**ANALYSIS**  
of  
**ACCIDENT MARTINAIR DC-10-30F, MP495**

**FARO, 21 DEC. 1992**

**Limited supplemental analysis  
including comments on the investigation**

**Limited Supplemental Analysis Of The Accident With Martinair DC-10-30F, MP495**

Fig. 4. Approach to Faro airport, based on the Approach Chart in Appendix 2.

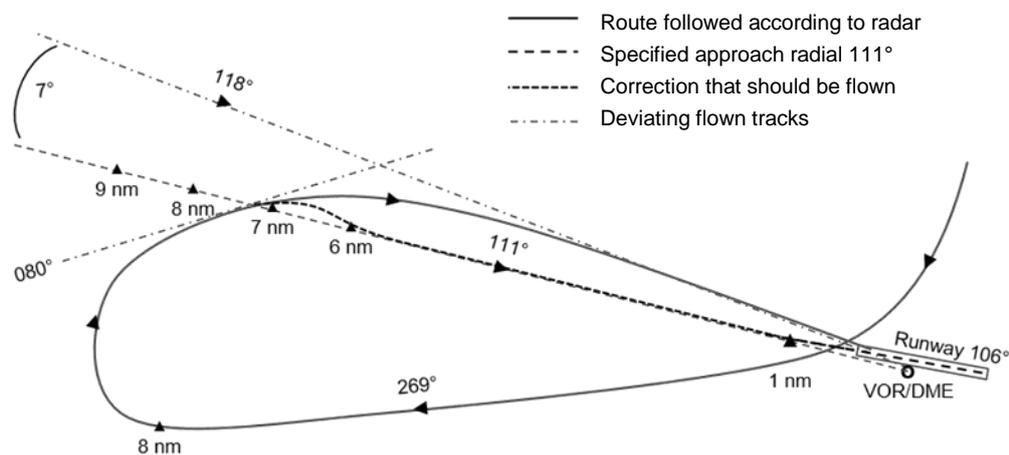
4.2.2. The approach path of the aircraft plotted in Appendix 2 and Figure 4 below shows that the turn towards the approach heading was already started at approximately 8 nm from the VOR beacon; this is too early according to the procedure and the permission given by traffic control, but it is sometimes left up to the pilot flying (if there is no other traffic). It was recorded on the CVR (07:26:43 UTC) that the captain gave permission to start the turn at 8 nm; nothing was mentioned about bad weather as a possible reason for the early turn. The approach radial of  $111^\circ$  was set at 07:28:36 UTC on the autopilot. Shortly afterwards the copilot says he wants a heading of  $080^\circ$  which the captain confirmed. A difference of  $30^\circ$  is normally used to intercept the approach radial ( $111^\circ$ ). When the approach radial is almost reached, the HSI indicates this and the heading has to be changed  $30^\circ$  to the approach radial. In this case the autopilot started the turn and reached the set heading of  $080^\circ$  exactly, as shown by the approach path drawn by the CvO. Whether or not the  $111^\circ$  approach radial was then set was not recorded on the CVR. Due to the approach radial not being set on the HSI, and an apparently late response when reaching the  $111^\circ$  radial the last turn on the radar plot in Appendix 2 looks rather affected by the wind as apparently the effect of the southerly wind was not considered.

The pilots must have been very aware of this major deviation from the approach radial as this must have been displayed very clearly on the two Horizontal Situation Indicators (and probably also on the two Attitude Director Indicators (ADI) in the cockpit). The corrective action, easing the heading to reach the correct approach ground course (VOR beacon radial), was not taken. It is possible that the pilots set a heading/radial directly to the VOR beacon.

Fig. 5. Wind correction for wind from  $190^\circ$  at 20 kt, and at an airspeed of 139 kt is  $8^\circ$  to the right. Therefore the heading must have been  $126^\circ$  (consistent with the DFDR).

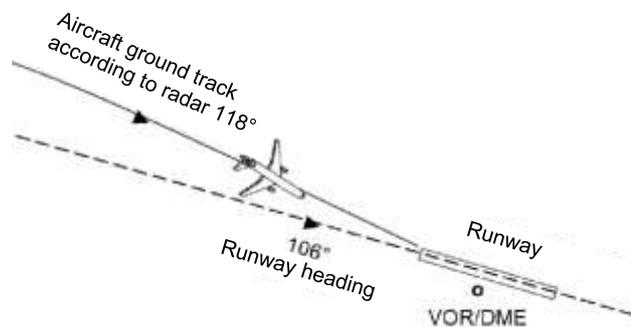
4.2.5. According to the radar, the ground track of the followed angled approach path was approximately  $118^\circ$ . The required wind correction angle for  $190^\circ/20$  kt wind was  $8^\circ$ , see Figure 5 below, hence the heading must have been  $126^\circ$ . That correspond with the heading of  $125^\circ$  recorded by the DFDR; a difference of  $1^\circ$ , a rounding error. Even from the start of the approach, after the last turn, there was insufficient wind correction into the direction of the crosswind at the time and, as shown by the radar plot (Appendix 2), the DFDR data (Appendix 3), summarised in Figure 4 above, no attempt at correction was made to fly to the approach radial. The approach path drawn by the Portuguese CvO (Appendix 2) shows that the aircraft never reached the extended centre line of the runway but approached the runway from the side. Hence the approach path was not within the required angle ( $2.5^\circ$ ) for a stable approach. The approach was not flown accurately and not according to the Approach Chart and can therefore definitely not be considered as a stable approach in accordance with the requirements of the FCOM (§ 4.2.3 above). This is another reason why the approach should have been aborted.

**Appendix 2. Approach Chart Faro Runway 11 with radar data plot MP495.**

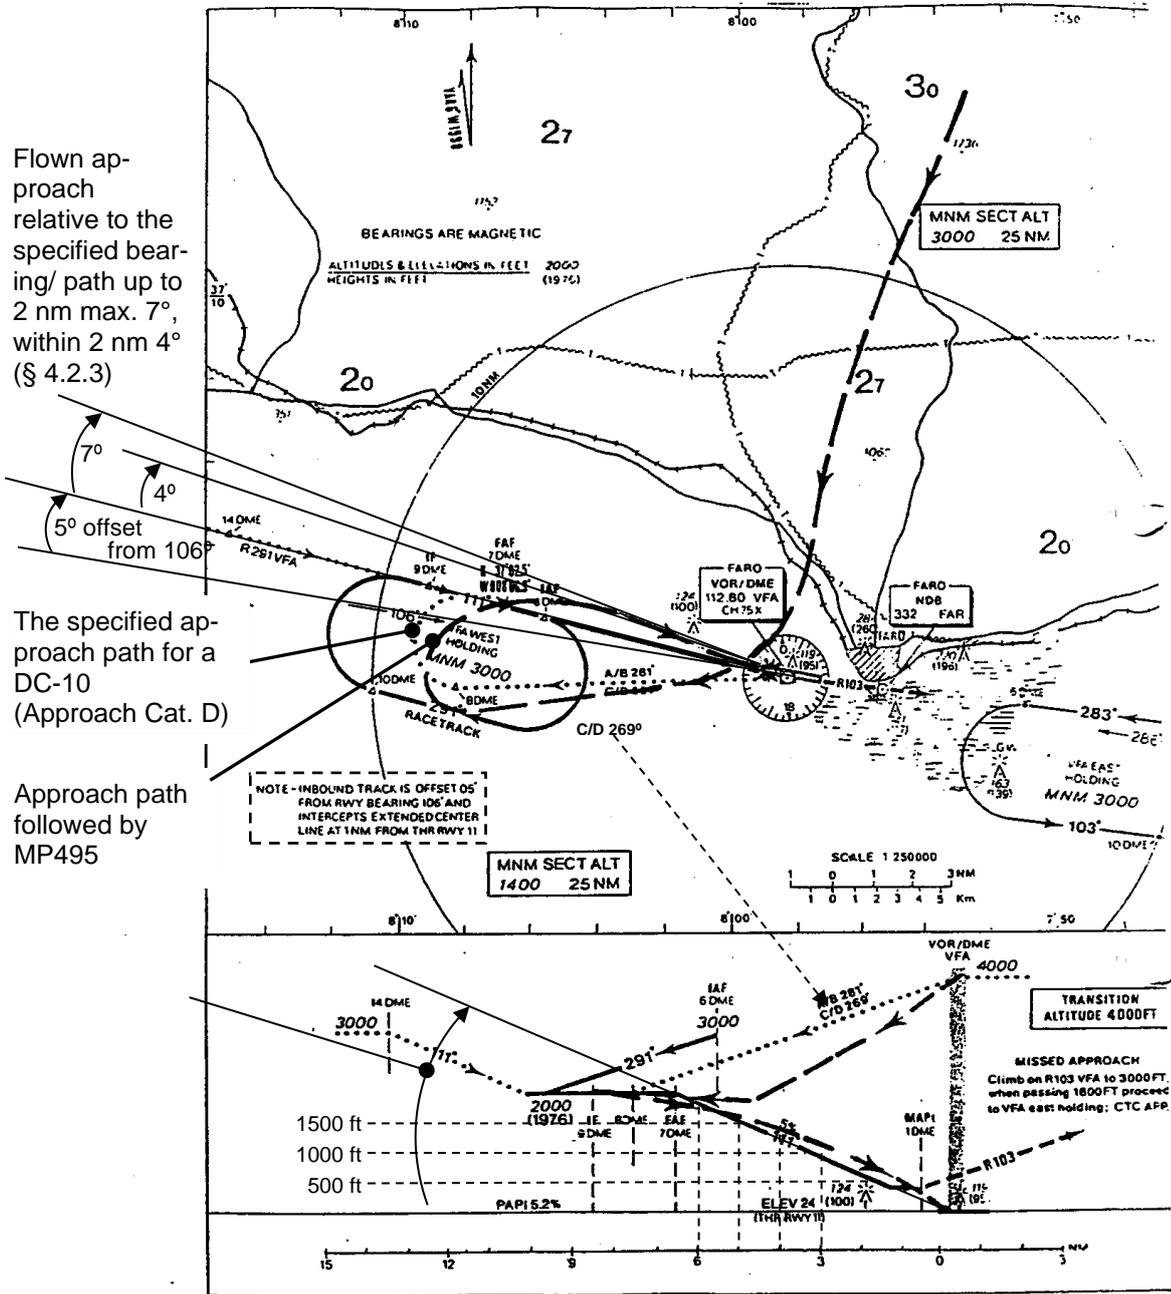
4.4.1. According to the radar plot in the bottom part of Appendix 2, the approach in the vertical plane, the glide path, was not flown accurately. The path drawn in shows that the aircraft was always flying above the glide path. However, that does correspond with the altitude readings by the captain during the approach, at 6, 5, 4 and 3 nm from the VOR/DME navigation beacon at the airport which were recorded on the CVR. These altitudes are also included in the plot and table in Appendix 2; they were flying up to 110 ft below the specified glide path. At 3 nm distance the altitude was still 70 ft too low, lower than the glide path drawn in the CvO. It could be that the source of the altitude data used by the CvO (a radar at a long distance) was not that accurate, see also § 4.1.3. It is also possible that the differences between the clocks used affected this (§ 2.2.3). The glide path indicated by the PAPI next to the runway was 5.2% (see Appendix 2), corresponding with a descent angle of almost 3°. When the correct PAPI glide path is followed (see footnote on page 3) the pilots see an equal number of red and white lamps; if the altitude is too low they see more red than white lamps. In any case, a correction was applied (§ 3.1.10). Differences were observed between the altitude data in the RvO and that in the NTSB's DFDR Factual Report (ref. 2, see also Table 1 on page 7). A better analysis would require the original DFDR graphs provided by the NTSB.

If the aircraft flies the specified glide path, at Faro 5.2% (= 2.98°), then at the listed DME distances the altimeter will show the altitudes in column QNH and the radio altimeter the altitude in column Radio. Distance PAPI to VOR/DME is approx. ¼ nm. Radio altitude = QNH - 24 ft runway elevation (if the terrain is flat). The altitude was slightly too low during the entire approach..

Appendix 3. Page 1 of RvO, Annex 15. Part of the NTSB's DFDR Factual Report (Ref. 2).

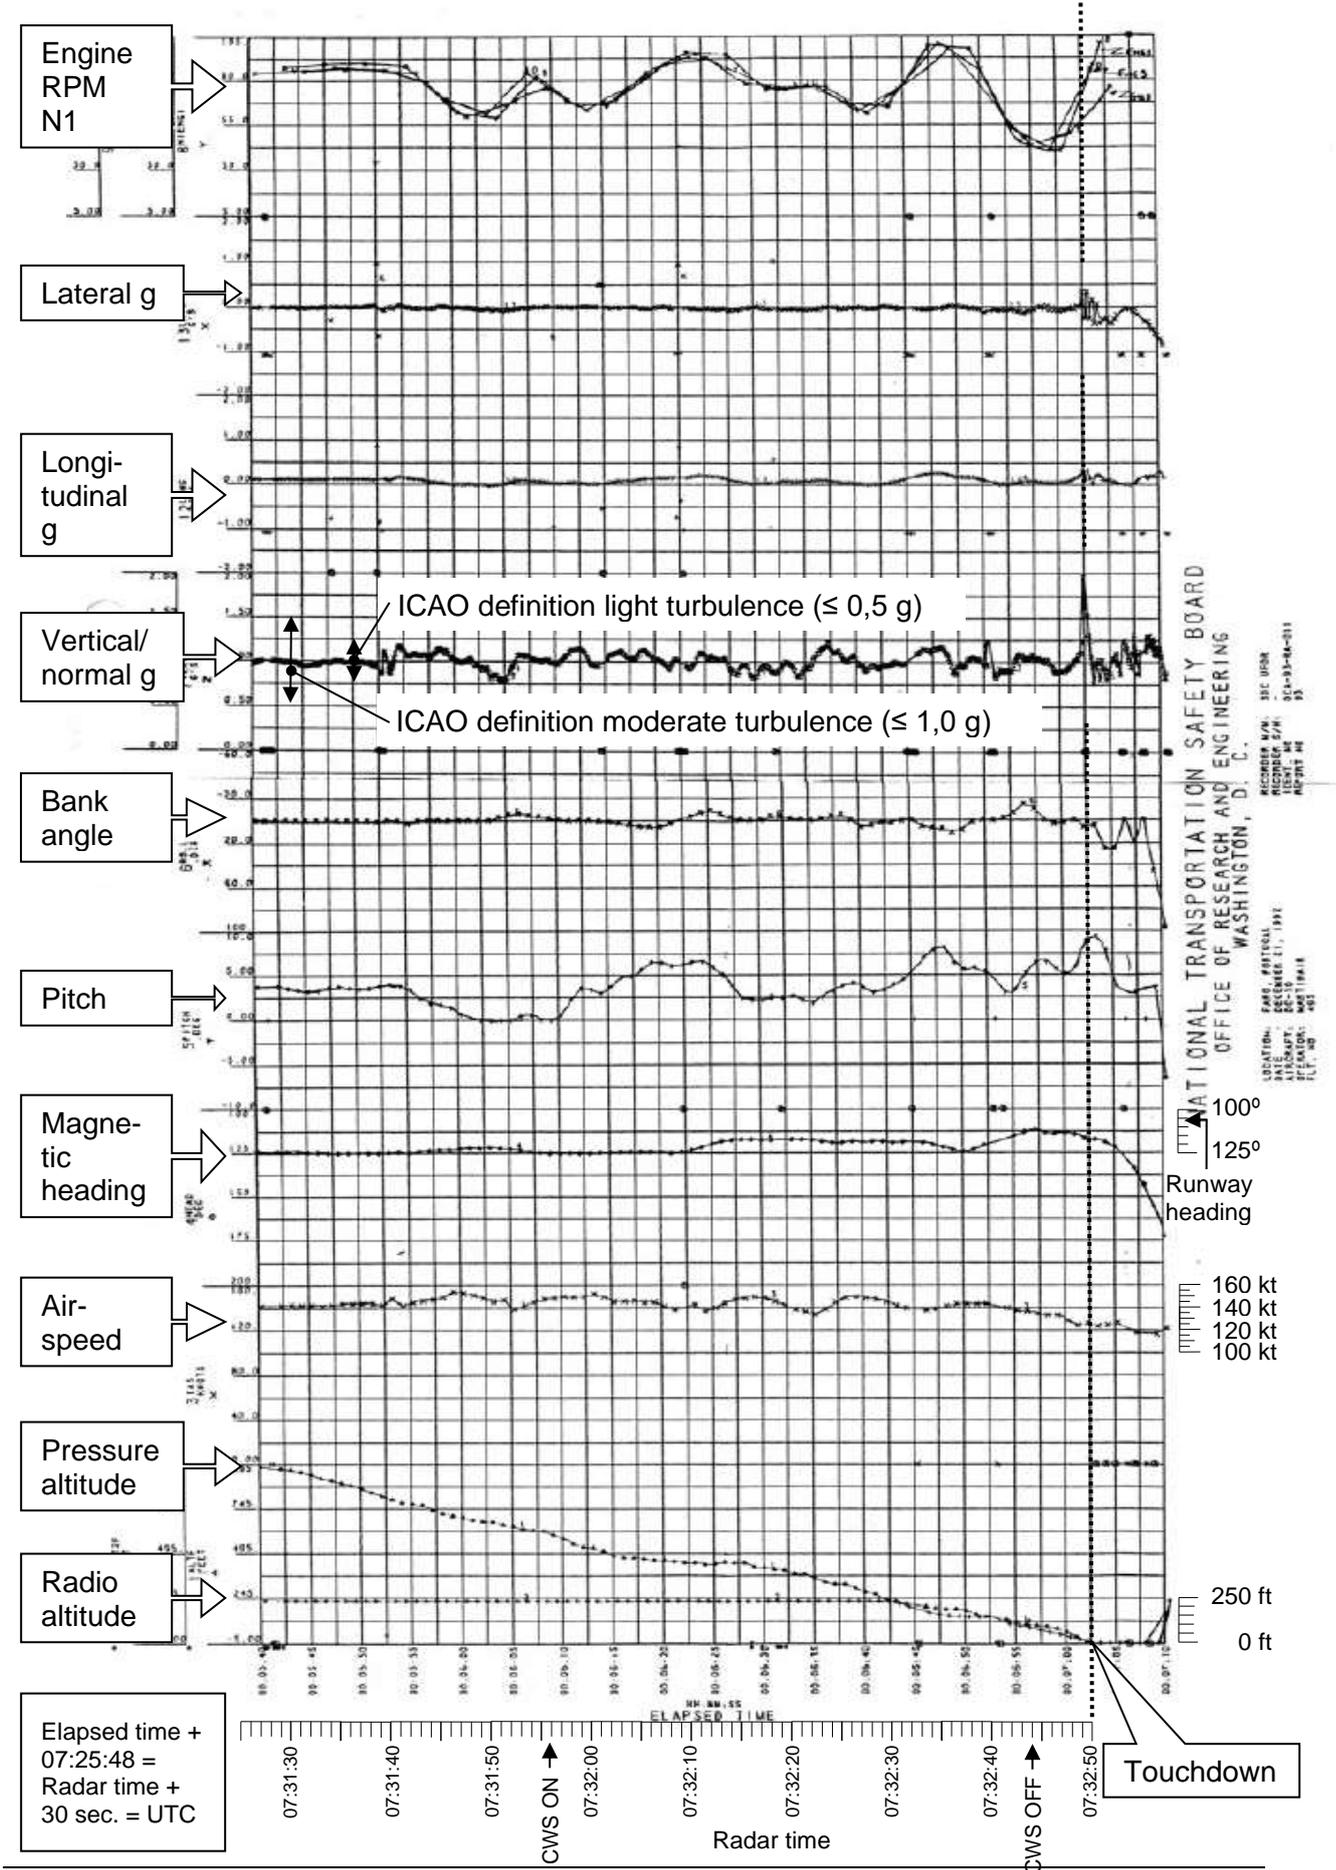
However, the graph of the magnetic heading in the NTSB report (Appendix 3) did not show any "oscillations" but only the heading change due to the early attempt by the pilot flying to align the longitudinal axis of aircraft with the runway heading by using the rudder. This movement was not successful, as discussed later in this analysis, so that landing was done with a crab angle which was not approved for a DC-10 on a wet runway.

5.2.9. According to the RVDL (ref. 5, page 7) a "high rate of descent" started from 80 ft altitude. The radio altitude graph in the NTSB report (Appendix 3) does not show at all that the rate of descent became high. The radio altitude graph in the RvO (e.g. Appendix 6) was deleted from 50 ft so that the high rate of descent is not evident in it at all. The DFDR was altitude available (for 7 seconds after the landing) but was not used. See also § 4.6.5.

Appendix 6. Graph 6 from the RvO, Annex 9. Rudder, brakes, roll angle

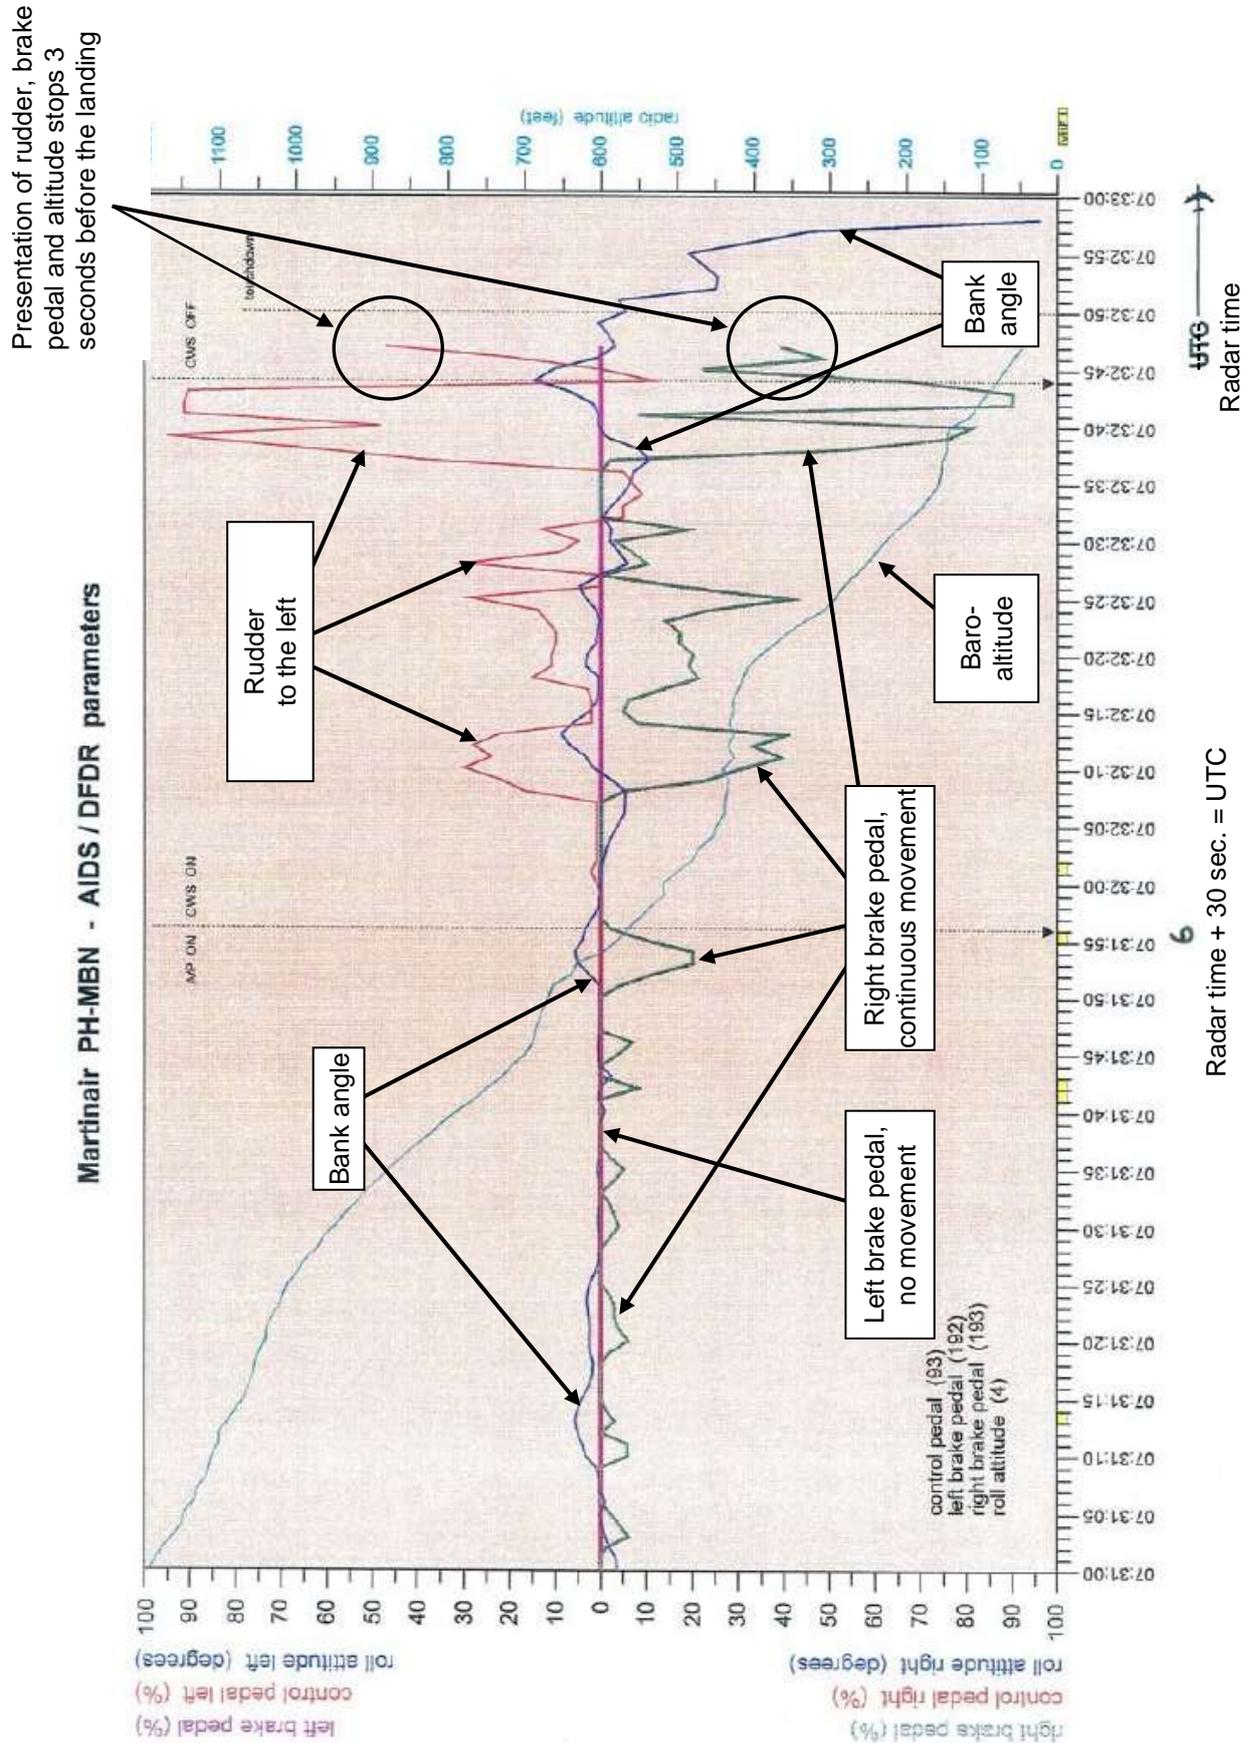
Graph 6 in the RvO (Appendix 9) shows that, certainly during the last minute and a half of the flight, the pilot flying regularly operated the right-hand brake pedal with up to 20% of the maximum travel. He continued doing that when CWS was selected; the movements even increased. This shows that a strenuous effort was made to line the aircraft up. The operation of the brakes during this stage of the flight certainly indicates that the pilot flying had not placed his right foot correctly on the pedals. The brake pedal graph stops 3 seconds before the landing, so that again the NTSB's DFDR Factual Report (ref. 2) will have to provide definite information, but it is

4.6.20. It appears that during the last minute and a half the pilot flying did not have his right foot in the correct position on the rudder pedals. Although again the last part of the relevant graph is missing, it can be stated with almost complete certainty that the right-hand brake pedal was pushed down and that some wheels of the right-hand main landing gear braked forcefully when the aircraft touched down which could have increased the forces on the landing gear during the landing so much that this may have led to the fatal collapse of the landing gear. The straight marks, initially in the same direction as the runway, show that the aircraft did not experience extreme lateral displacement at the time of the touchdown. The incorrect placement of the feet on rudder controls, and not just the traversing landing, may have resulted in the collapse of the right landing gear. These are results of incorrect action by the pilot, with serious consequences.

pendix 6) was that the pilot flying moved the rudder almost fully to the left to line up the longitudinal axis of the aircraft with the runway heading. The engines had gone to 102% 15 seconds before that (due to the speed decrease and pitch increase to get back to the glide path (see § 3.1.3, § 3.1.10 and Appendix 7) and due in part to this the descent briefly reduced, but the speed did not increase. The accelerations in the three axes did not show anything unusual. There were absolutely no insurmountable external problems, other than the crosswind.
